DEPARTMENT OF TRANSPORTATION**Federal Aviation Administration****14 CFR Part 39**

[Docket No. FAA-2015-7527; Directorate Identifier 2015-NM-094-AD; Amendment 39-18686; AD 2016-21-05]

Airworthiness Directives; The Boeing Company Airplanes

ACTION: Final rule.

Figure 1 to paragraph (h) of this AD: Wiring Installation - Right Engine Fuel Spar Valve

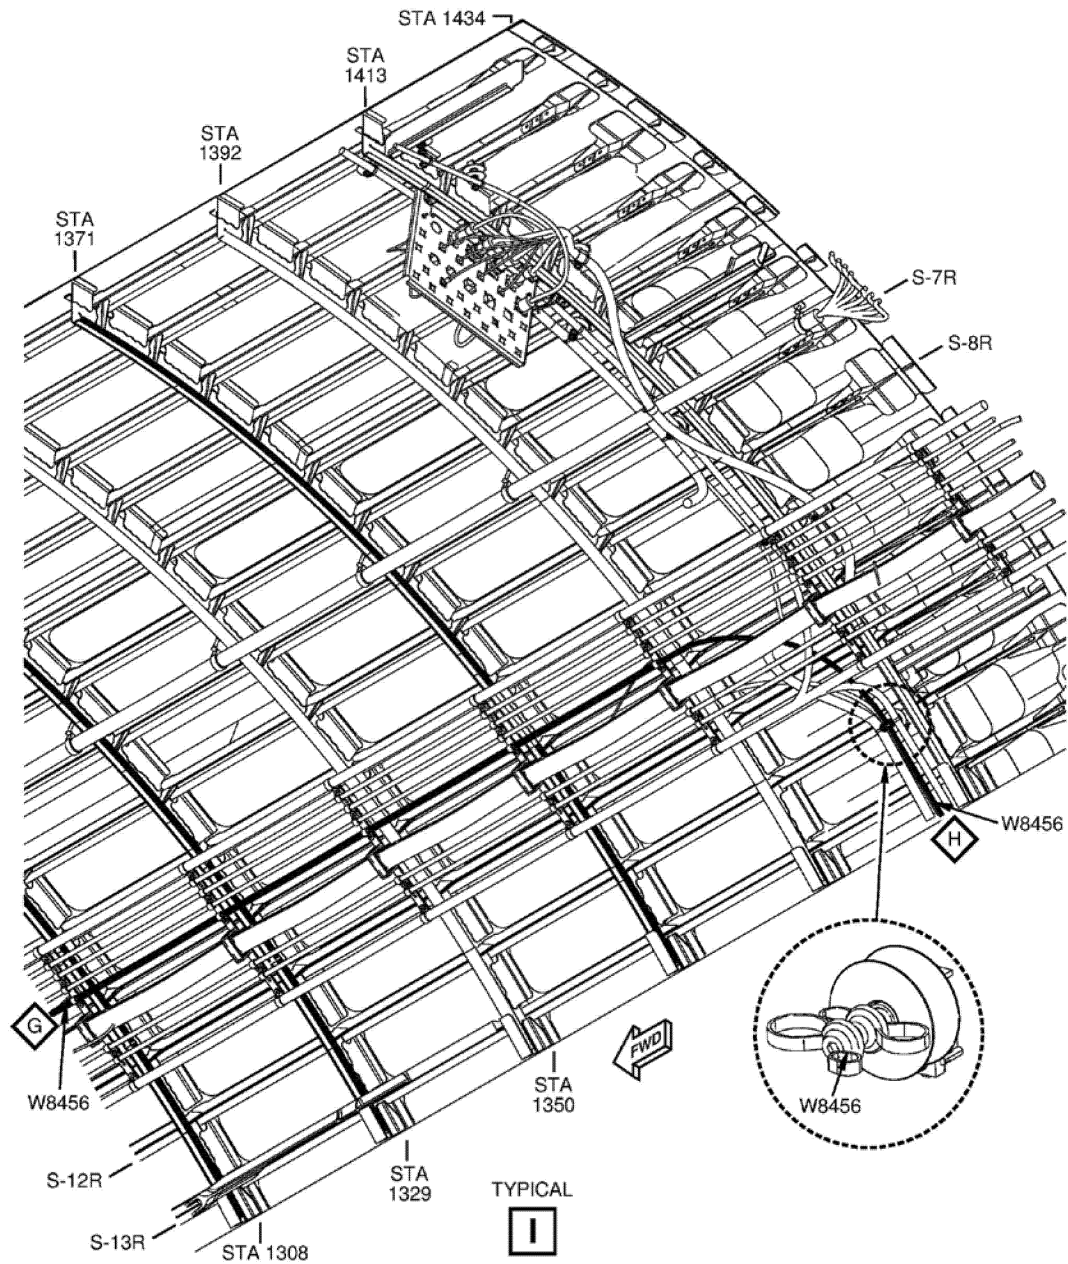
appropriate source of service information in this AD because it is not an FAA-approved document. However, we acknowledge that for certain airplanes, Figure 22, Sheet 9, of Boeing Special Attention Service Bulletin 777-28-0061, Revision 2, dated May 4, 2015, includes an editorial error, which shows incorrect wire routing. Boeing Service Bulletin Information Notice 777-28-0061, IN 03, dated November 16, 2015, allows for a modification of Group 2 airplanes that meets the requirements of the AD without an additional burden to operators. We have included a corrected figure in paragraph (h) of this AD to address this issue.

(1) Where Boeing Special Attention Service Bulletin 777–28–0061, Revision 2, dated May 4, 2015, specifies to use Figure 22, Sheet 9, for the wiring installation of the right engine fuel spar valve, this AD requires using figure 1 to paragraph (h) of this AD.
